**DOCUMENT 00 90 00  
ADDENDUM**

**ADDENDUM NO. [2]                      Date: January 19, 2018**  
**RE:                      ABBOTSFORD SCHOOL DISTRICT**  
**ELEMENTARY & MIDDLE SCHOOL ADDITION**  
**510 HEMLOCK STREET**  
**ABBOTSFORD, WISCONSIN 54405**  
**HSR PROJECT NO. 17060**

**P100R**

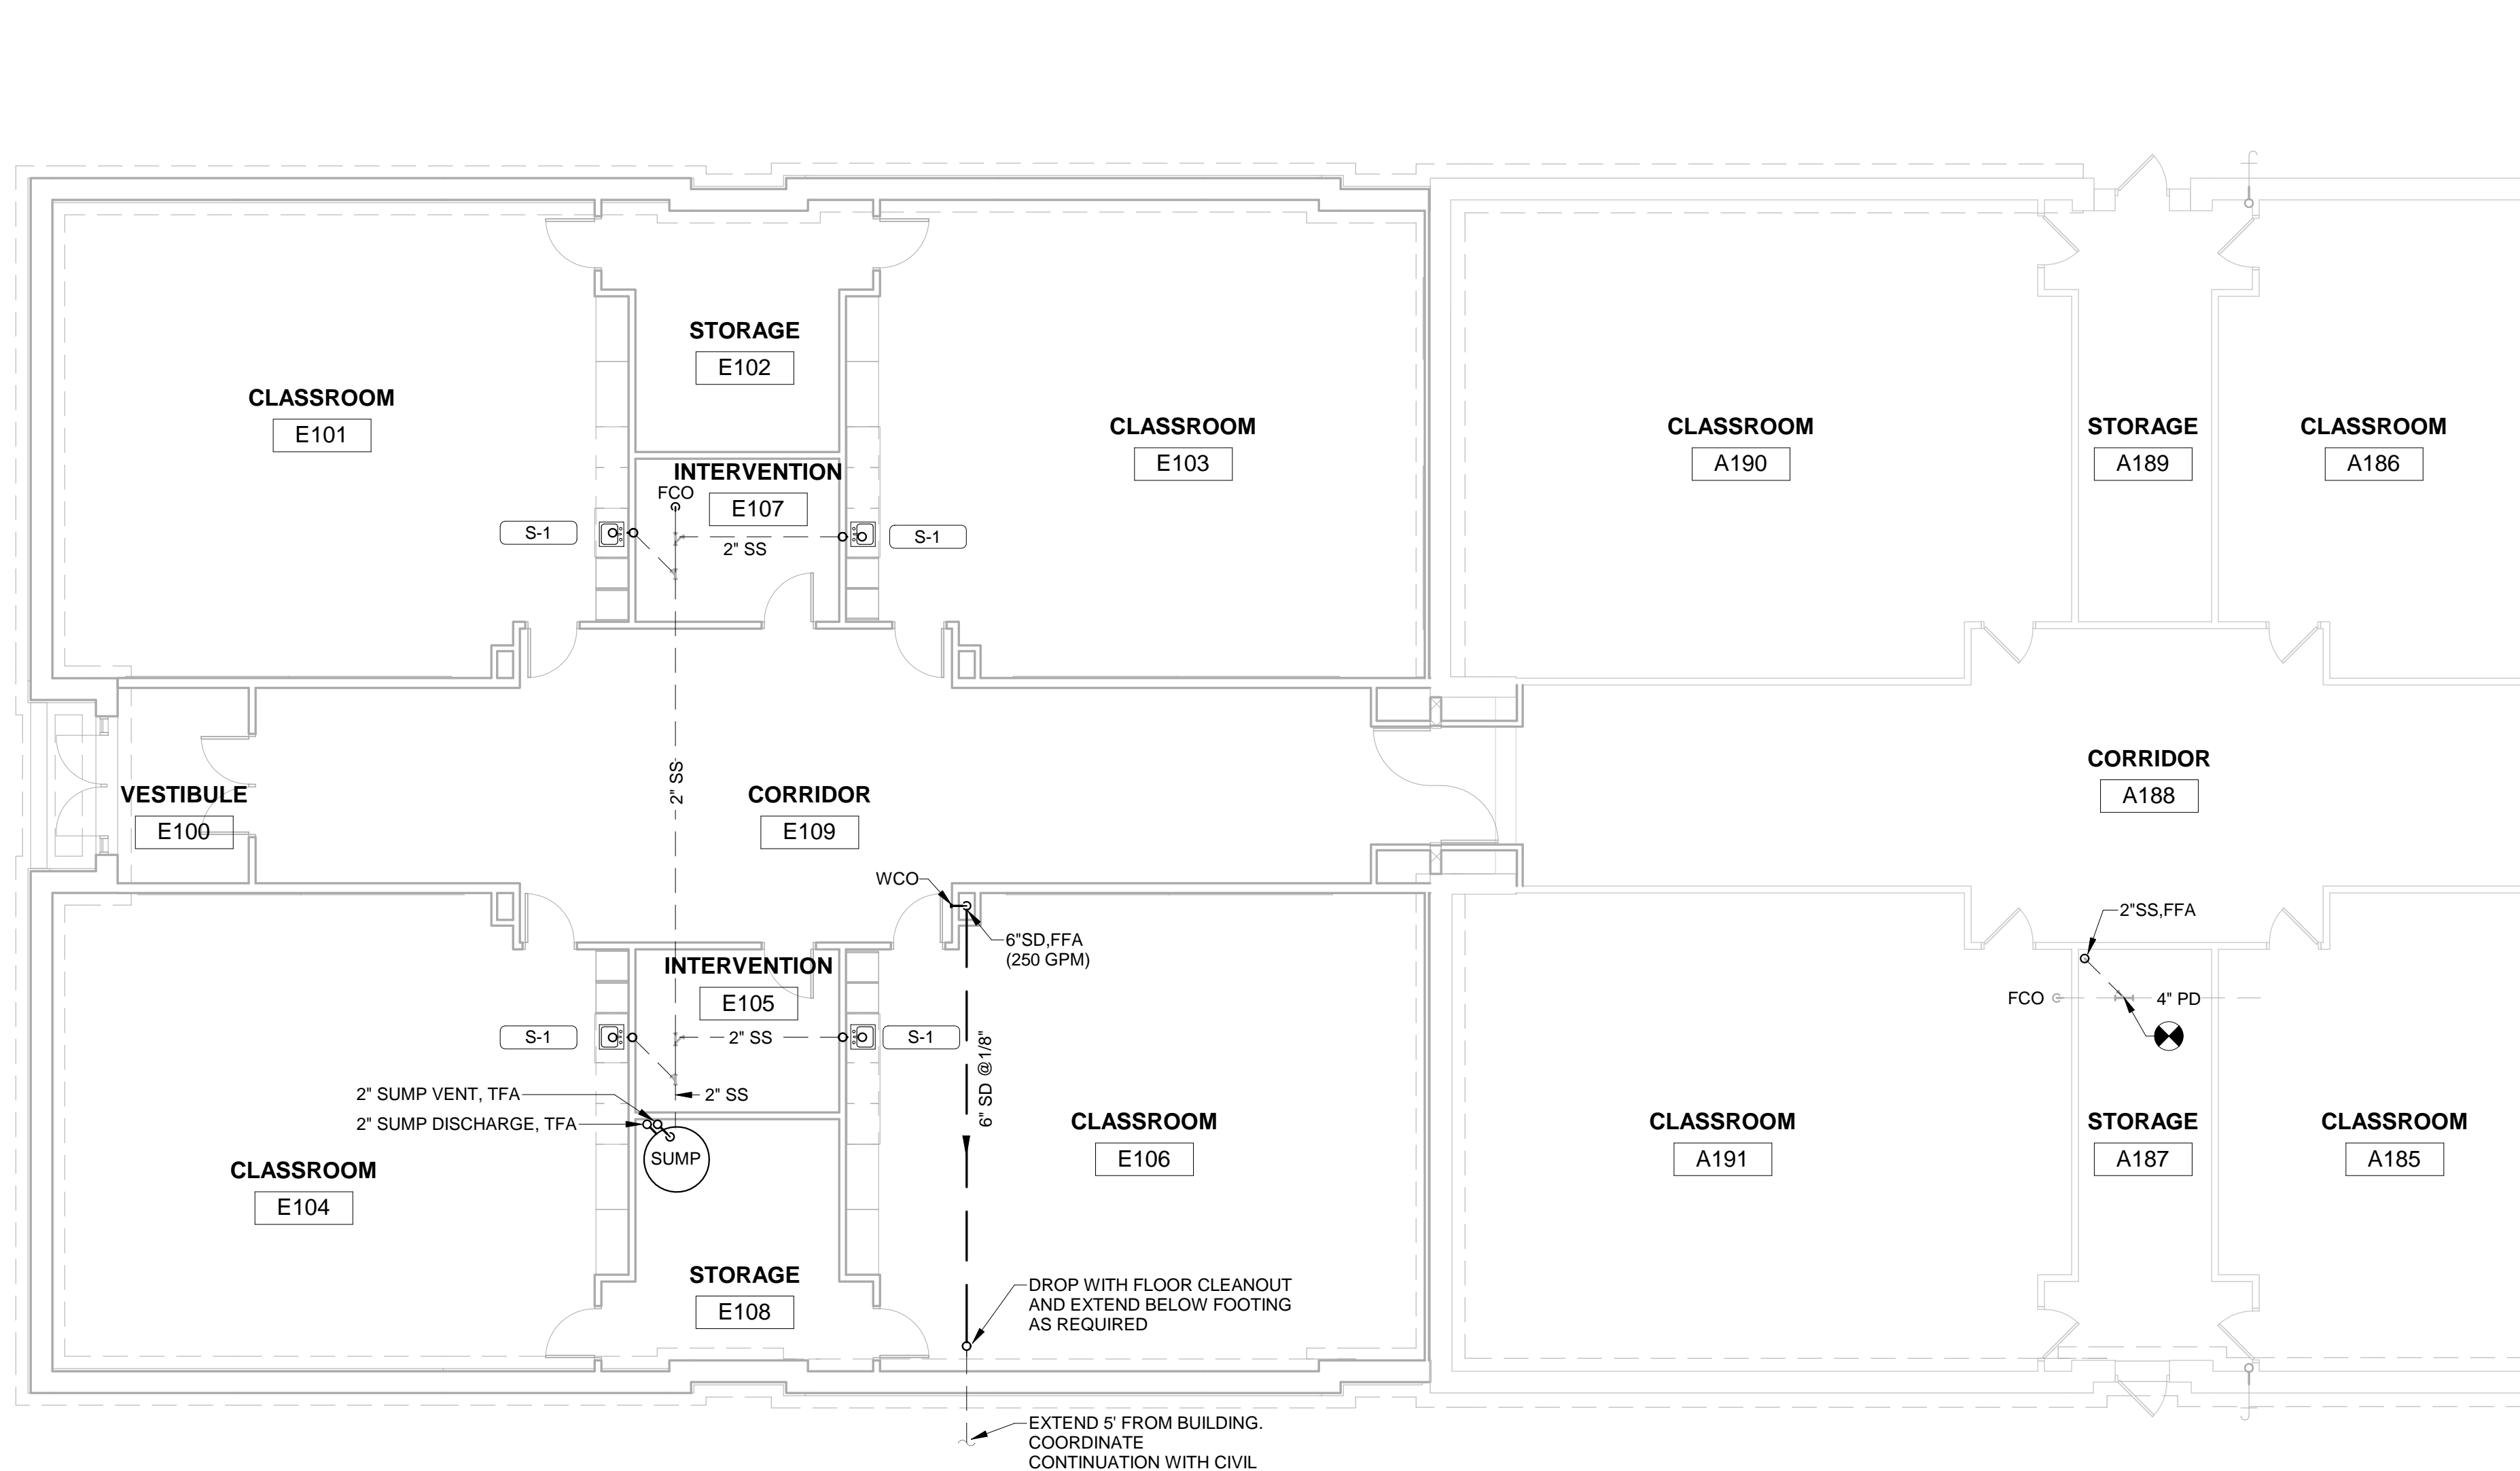
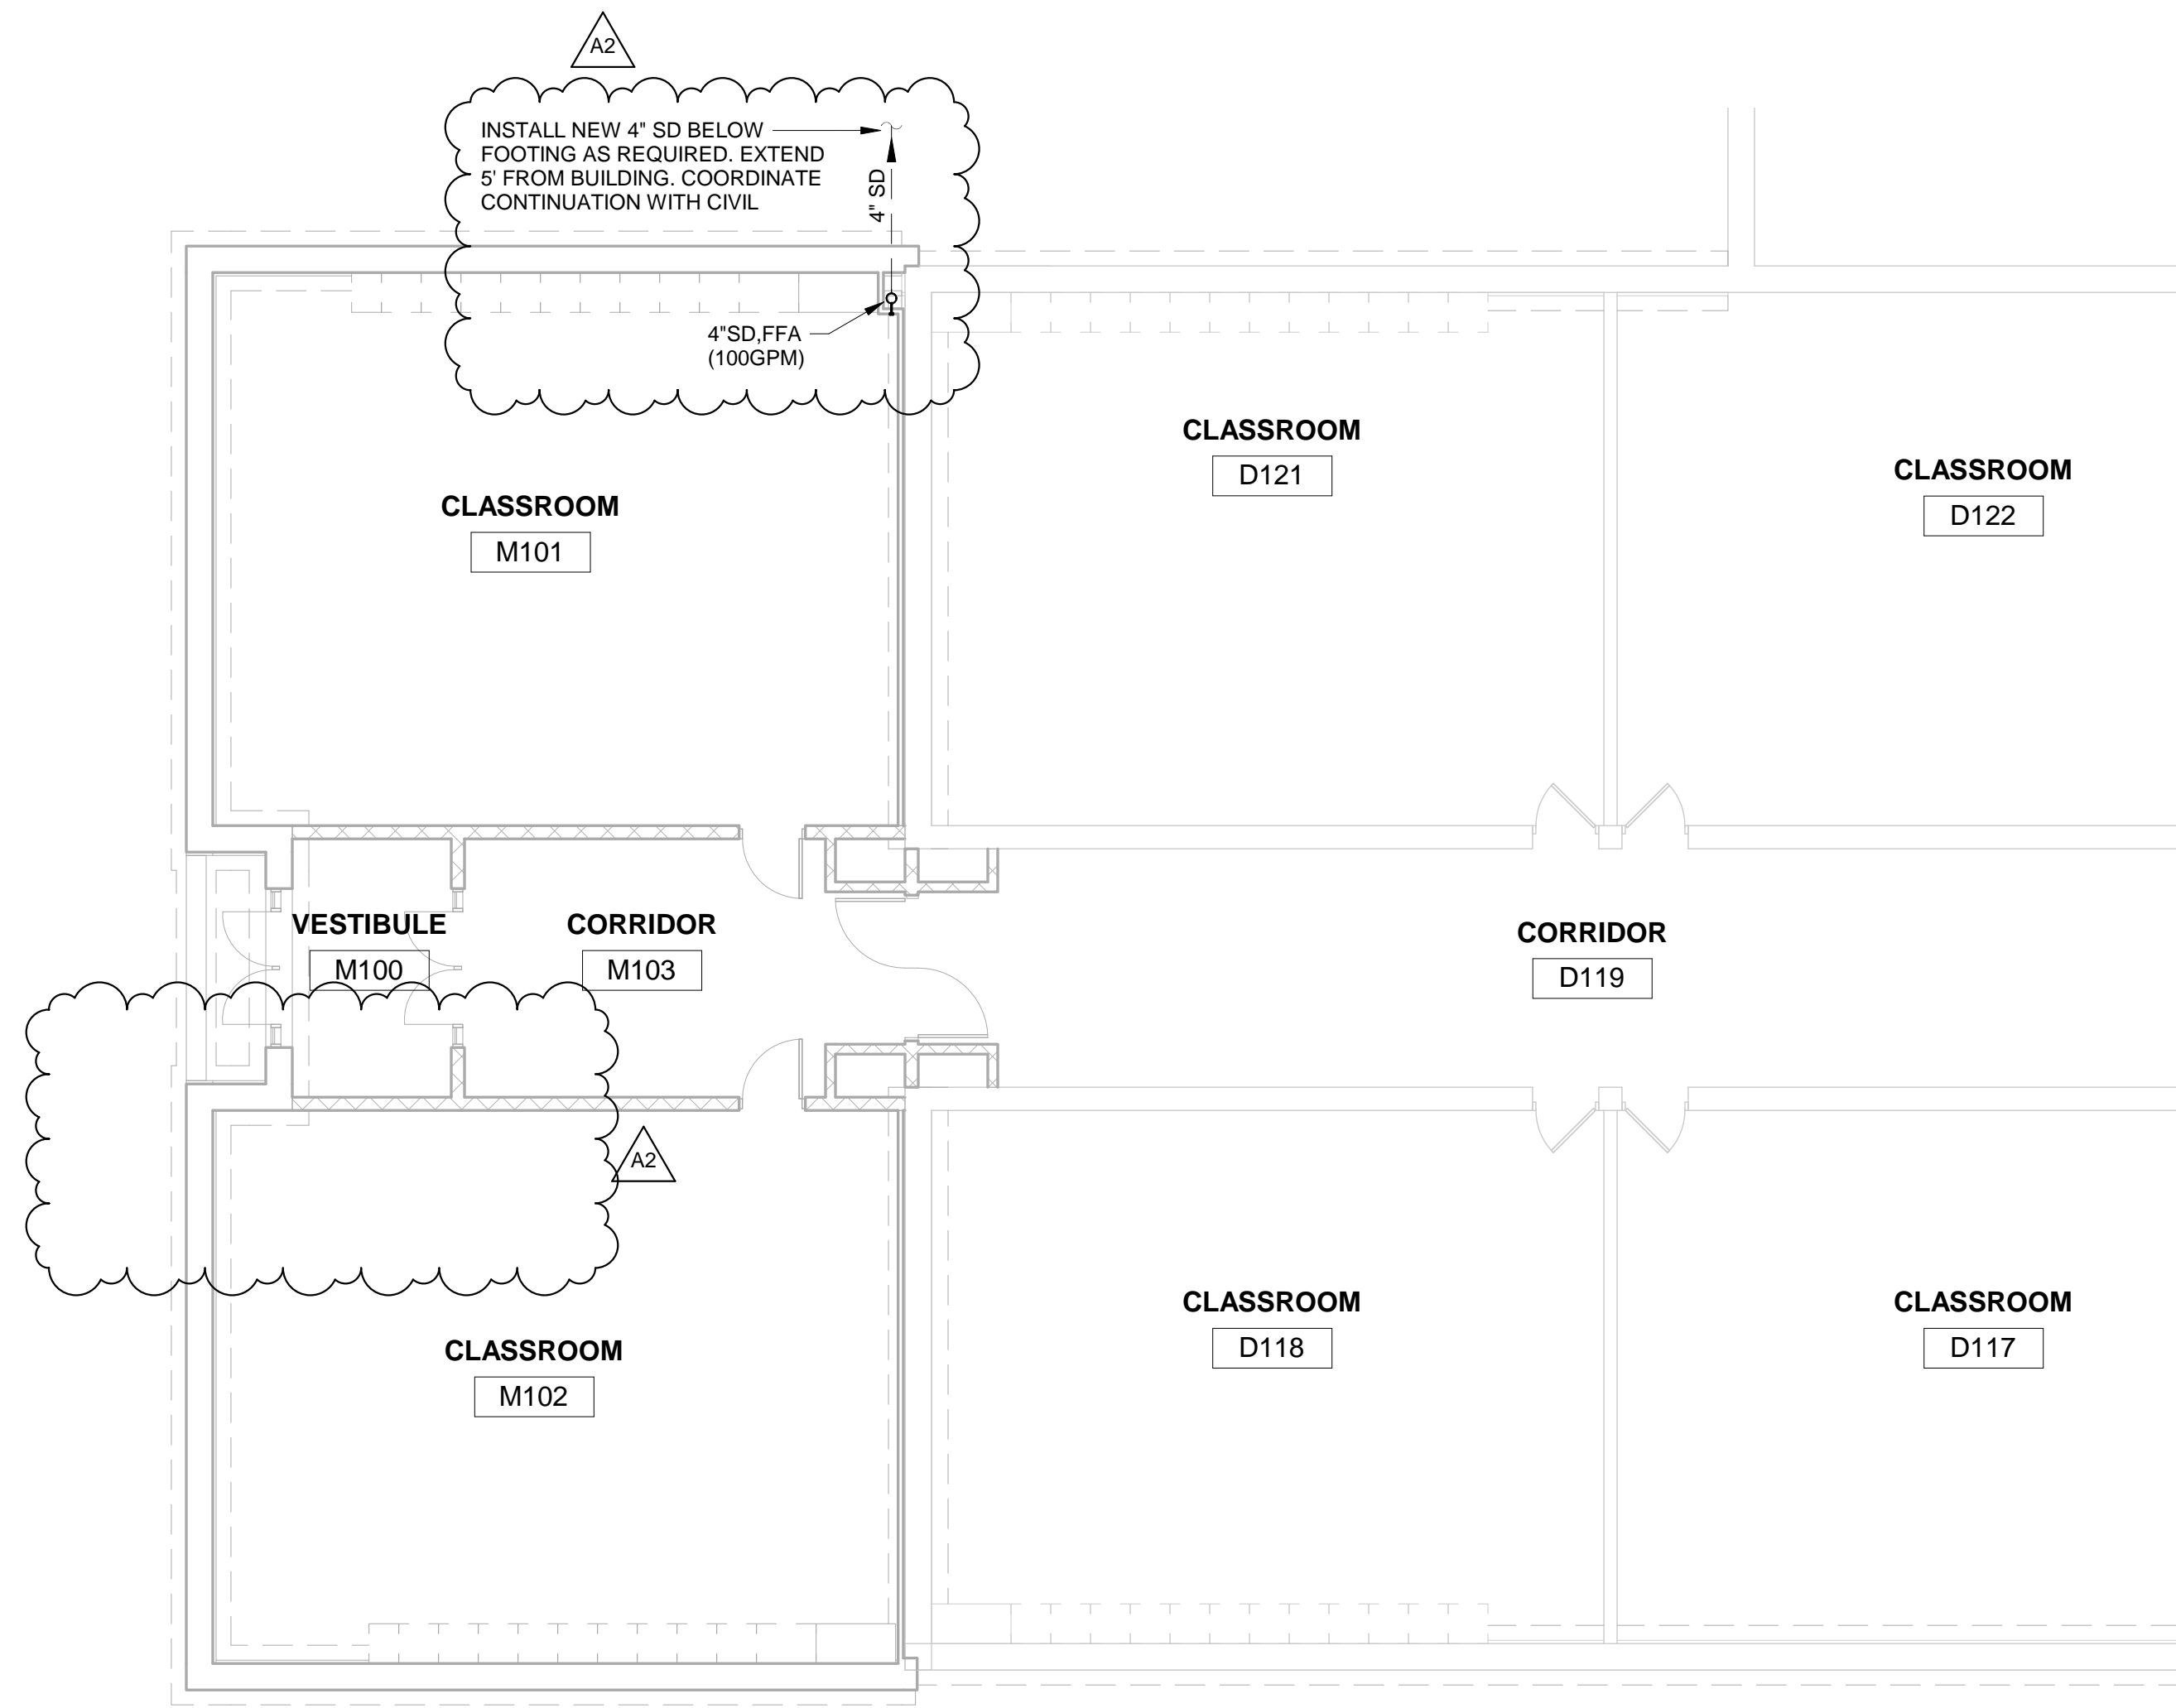
- a. Joist bearing elevations adjusted.
19. Sheet P100R PLUMBING REMODEL PLAN 30 x 42 attached hereto
  - a. 1P100: At elementary Storage 187, refer to A100 for extents of concrete floor removal for new piping.

- b. 4P100: Roof drain piping has been redirected to northeast corner of Classroom M101 for connection to existing catch basin directly outside. Refer to C200R attached hereto.
